## Replacing an EEBD 6600.1 cross bar

### Problem description:

The doors for the water tank of appliances with an "old" cross bar may be out of line. This problem can be solved by replacing the cross bar, spare-part no. 542644.

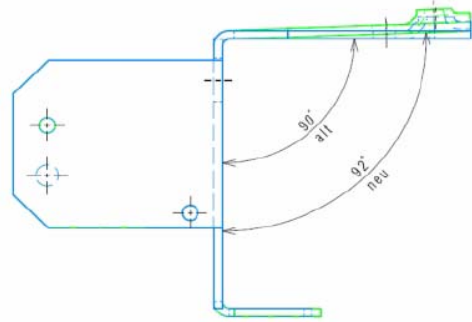
7. Now the cross bar in pos.12 can be removed.

8. Once it has been removed, the "old" cross bar can be compared to the "new" one.
